ORIGINATION FORM

Proposed Revisions to a Standard Plans Index
(Please provide all information — Incomplete forms will be returned)

Index Number: 102-604
Sheet Number (s): 1 and 2 of 2
Index Title: Two-Lane, Two-Way, Intersection Work

TWO-LANE, TWO-WAY, INTERSECTION WORK

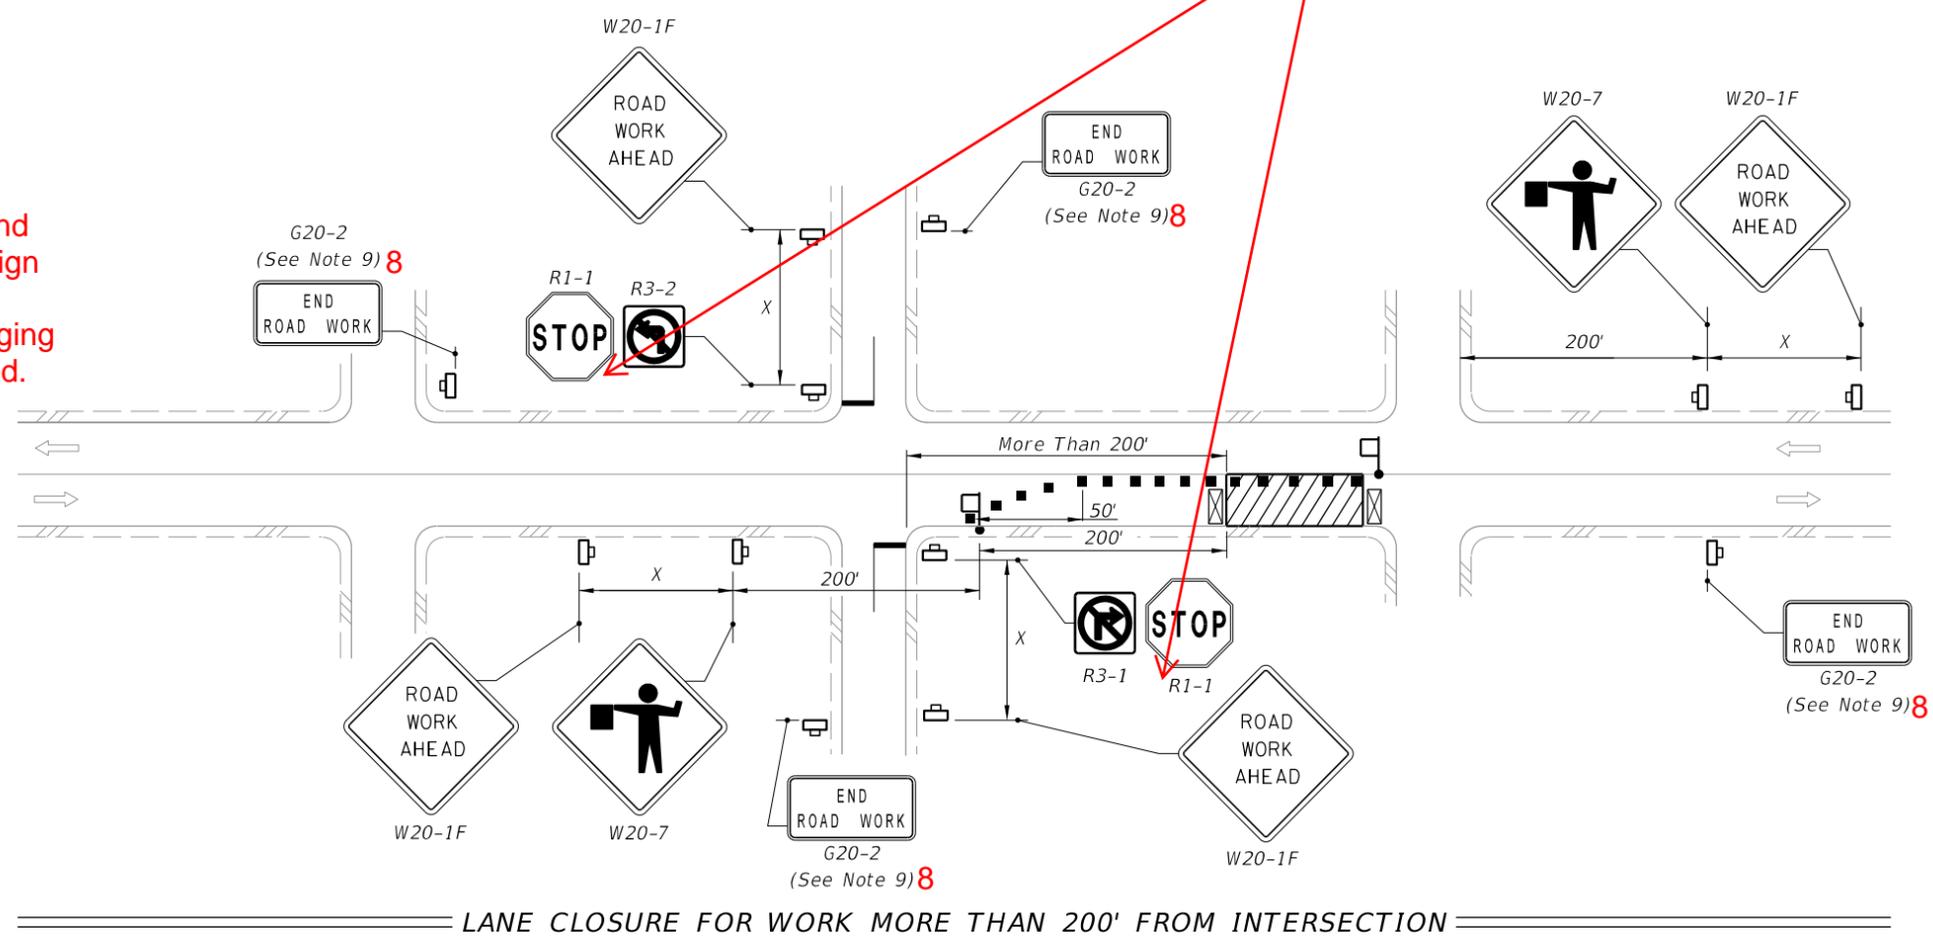
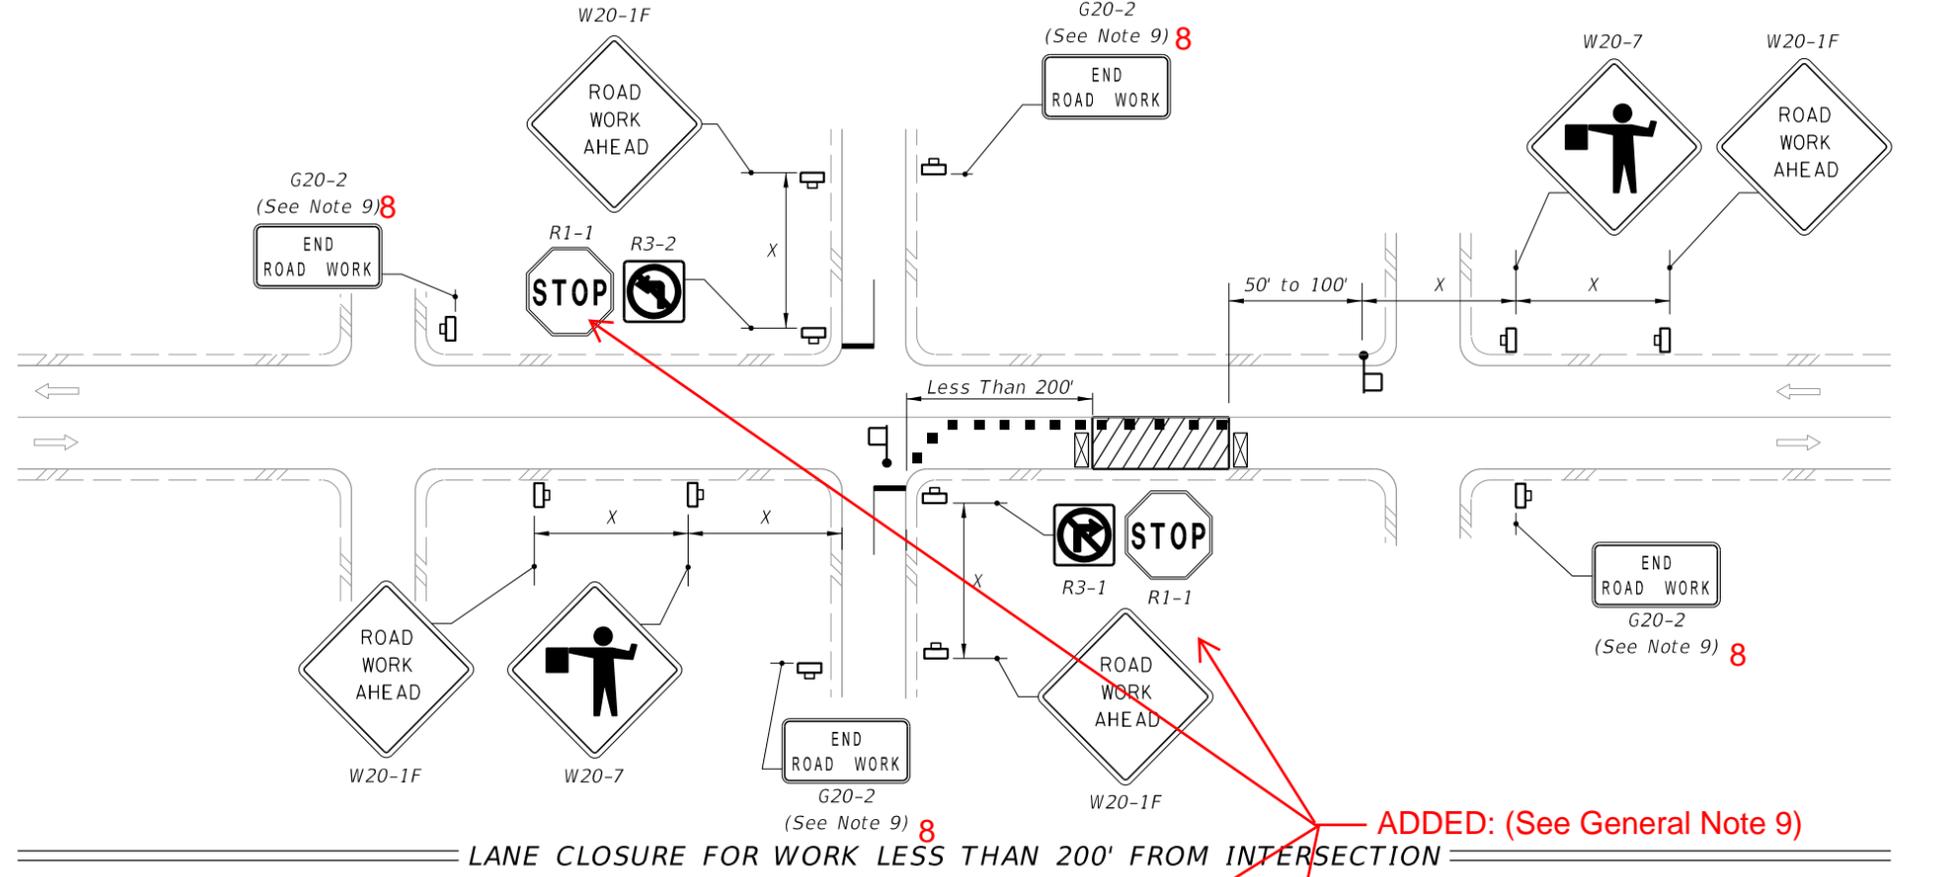
Sheet 1: Deleted Note 9; Added New General Note 9: "As an option to the "STOP" sign (R1-1) and Restricted Left/Right Turning Movement sign (R3-1 or R3-2), the "SIDE ROAD INTERSECTING THE WORK ZONE" flagging operation from Index 102-600 may be used.". Added (See General Note 9) at intersections with R1-1 and R3-2 signage.

~~9. If the work encroaches on a marked bicycle lane or rideable shoulder, close the lane or shoulder in accordance with the Plans.~~

9. **DELETED: Note 9.**

ADDED New Note:
As an option to the "STOP" sign (R1-1) and Restricted Left/Right Turning Movement sign (R3-1 or R3-2), the "SIDE ROAD INTERSECTING THE WORK ZONE" flagging operation from Index 102-600 may be used.

ADDED: (See General Note 9)

Note 9 was added to help clarify that the side road flagging index can be used instead of the sign layout shown at the side road intersections. The flagger was moved to be in the correction position on the roadway.

WORK IN INTERSECTION OF TWO-LANE ROADWAY

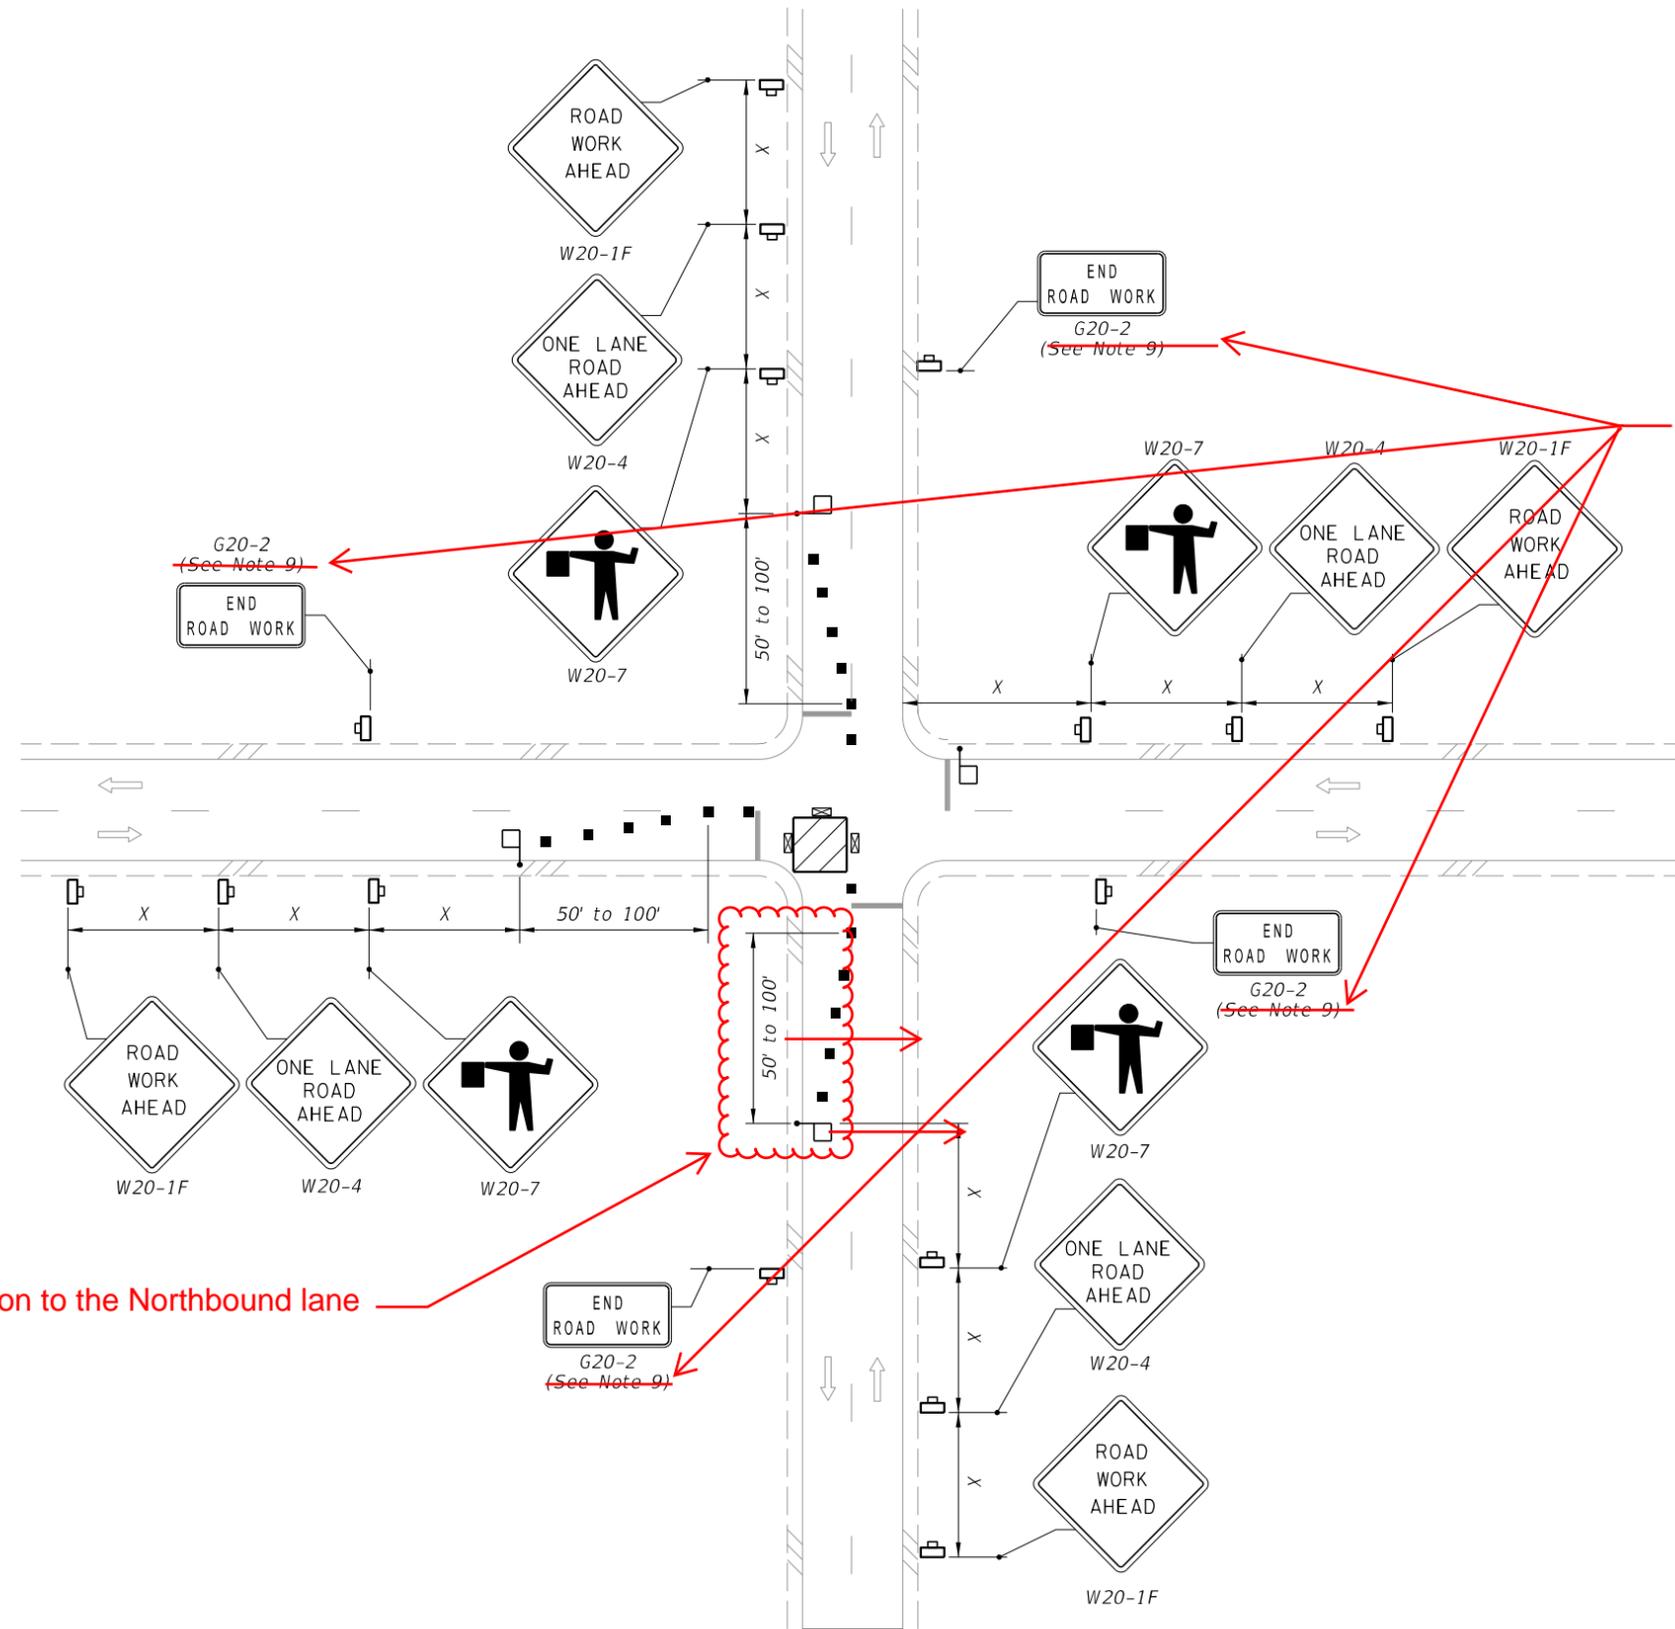
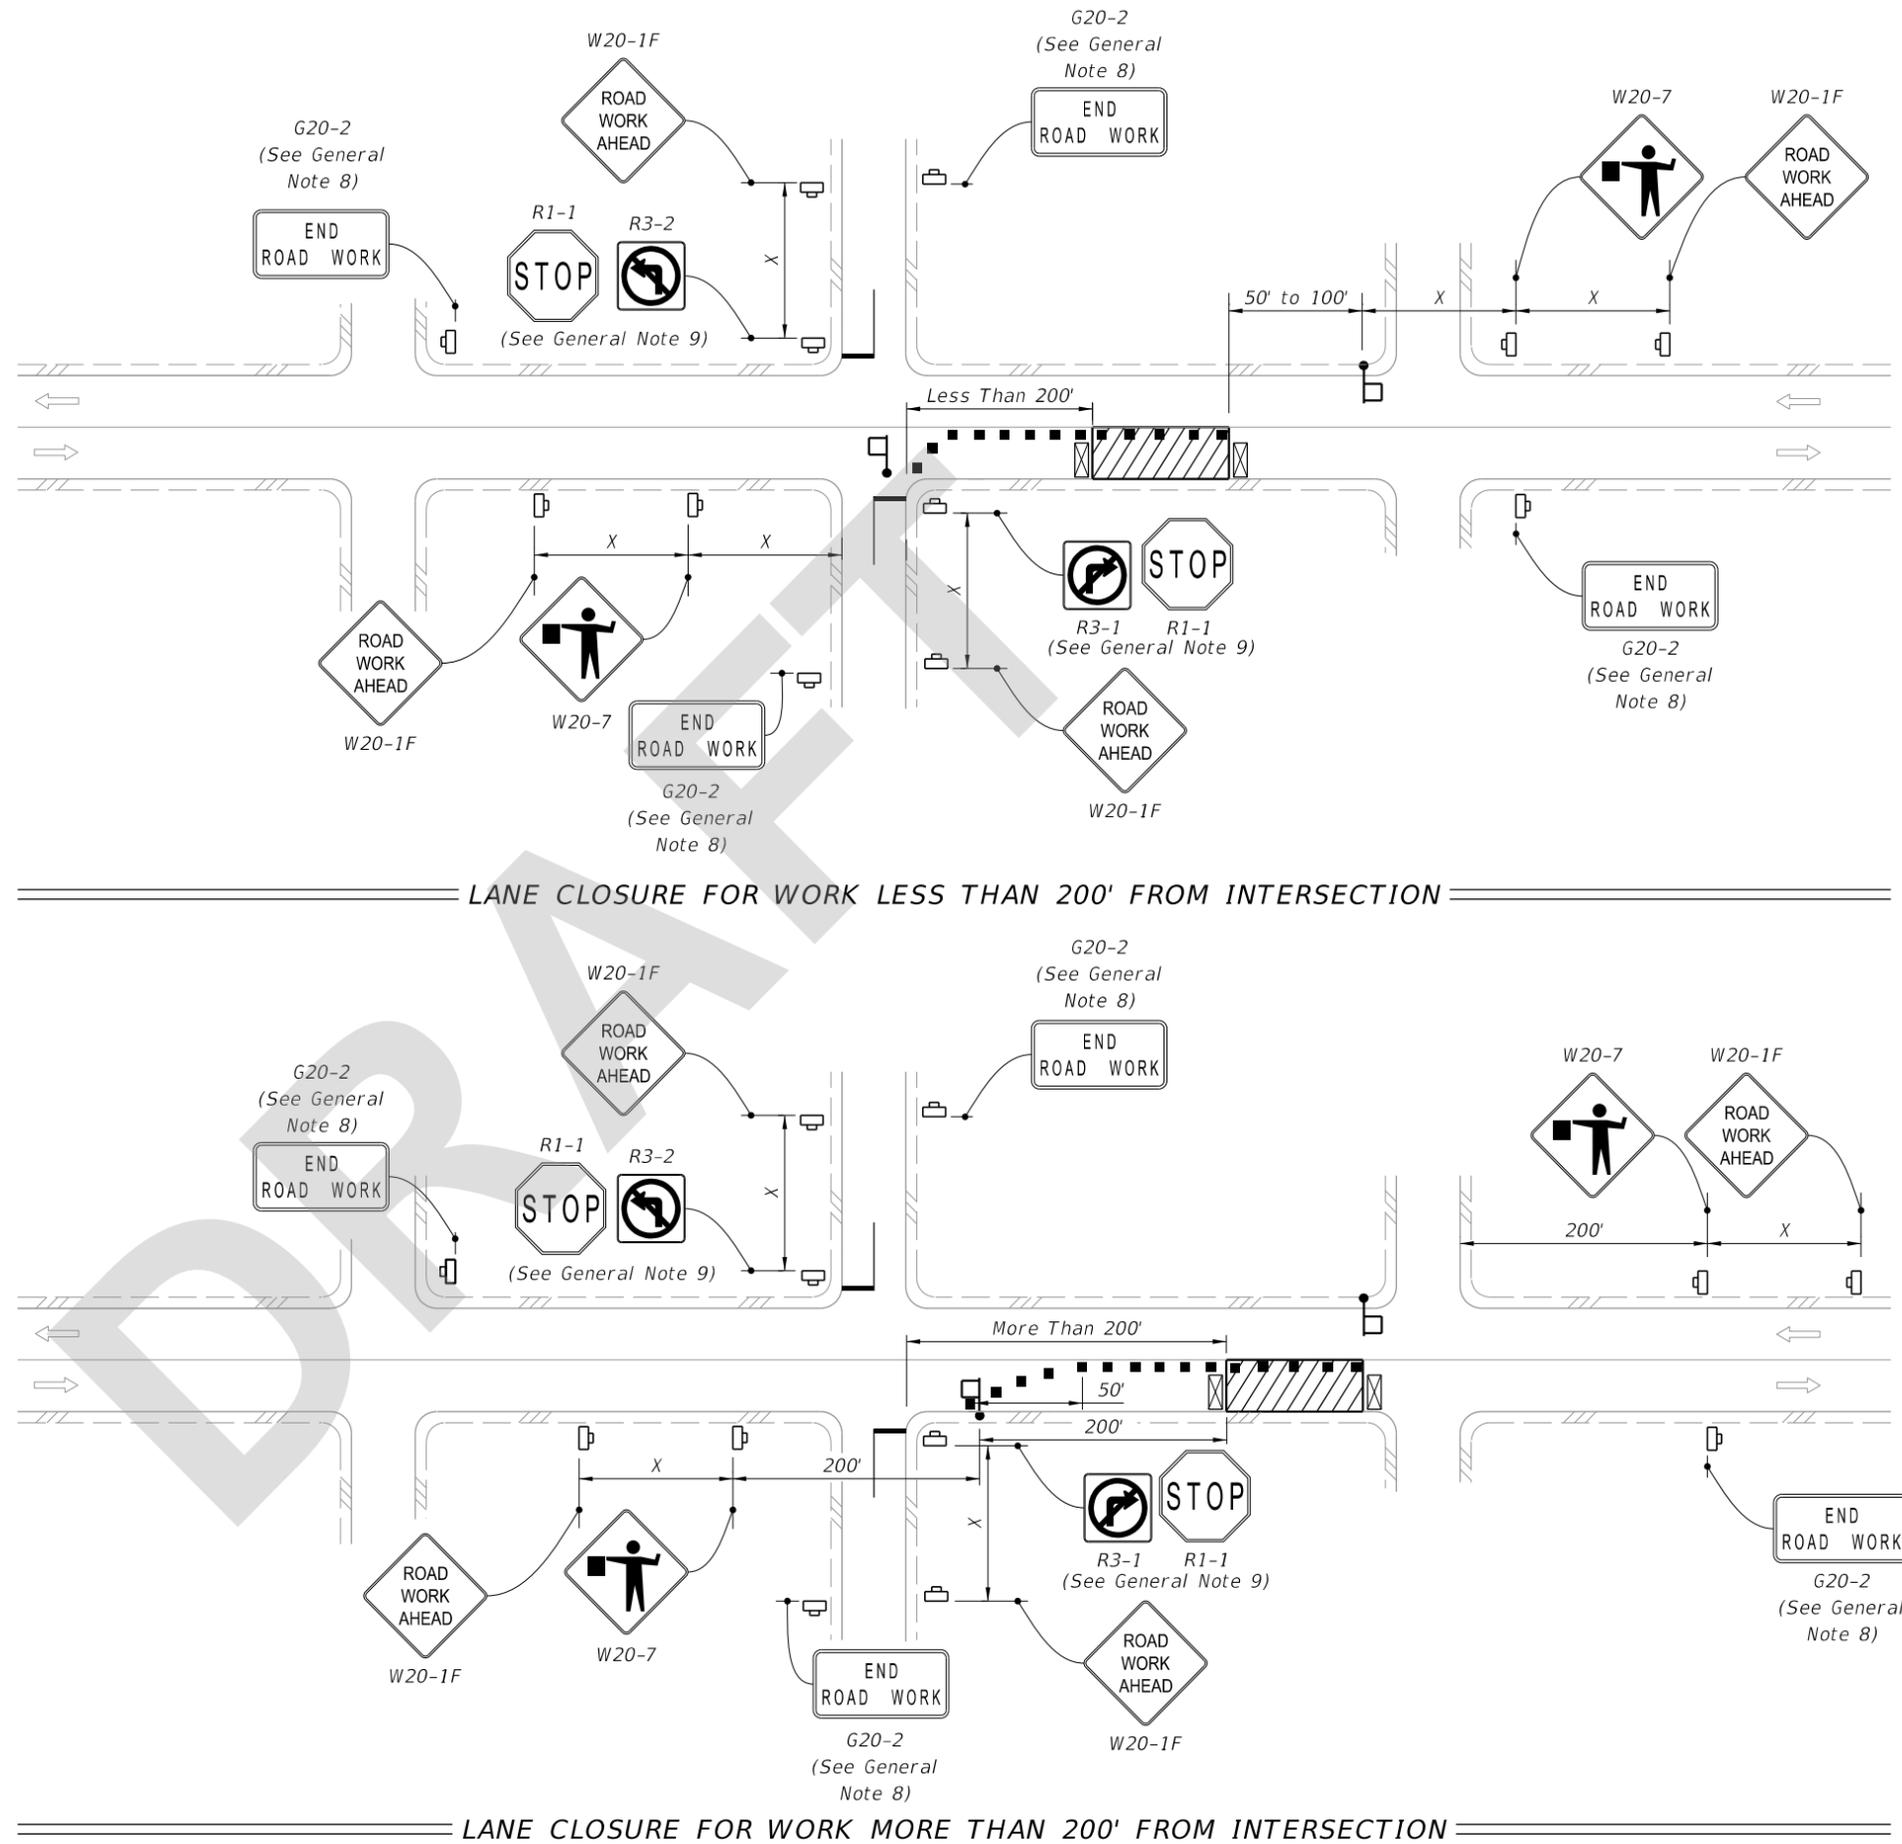
Sheet 2: Moved the Flagger and associated dimension on the Southern lanes of the detail, from the southbound lane to the northbound lane.

MOVED: Flagger and Dimension to the Northbound lane
